MORGAN AND MORECAMBE OFFSHORE WIND FARMS: TRANSMISSION ASSETS

Errata

Deadline: Deadline 4
Application Reference: EN020028

Document Reference: S_D1_14/F04
Rev: F04

A.1 MCZ Assessment – Figure 1.7

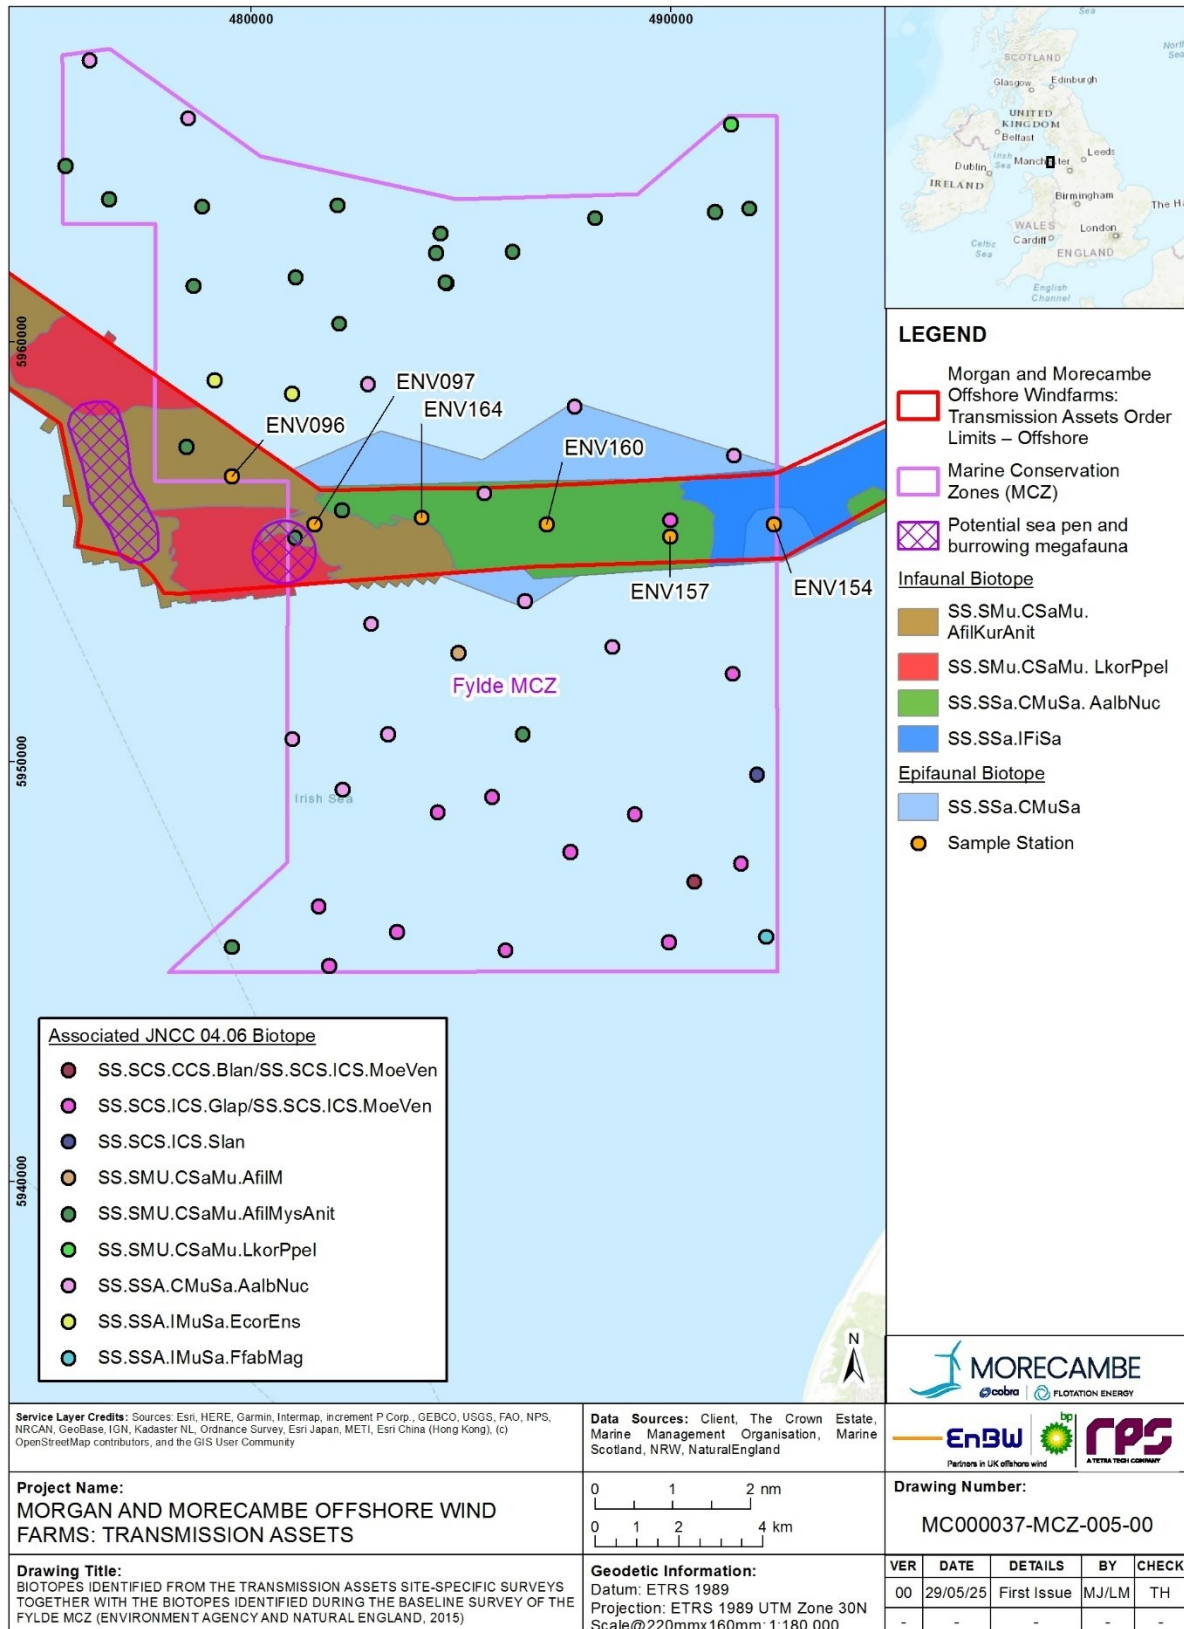
Errata document version	Document section	Description of errata
F01	Figure 1.7	The Applicants can confirm that the potential 'seapen and burrowing megafauna communities' IEF mapped in Figure 1.22 of Volume 2, Annex 2.1: Benthic subtidal and intertidal ecology technical report (APP-046) was erroneously missed from Figure 1.7 of the MCZ Screening and Stage 1 Assessment Report (APP-019). Figure 1.7 has been updated for Examination at Deadline 2 (see 1.16).
F01	Table 1.6	The Maximum design parameter for the Maximum total volume of cable protection (m ³), within MCZ (shown in the last row of the table) should be 30,400.
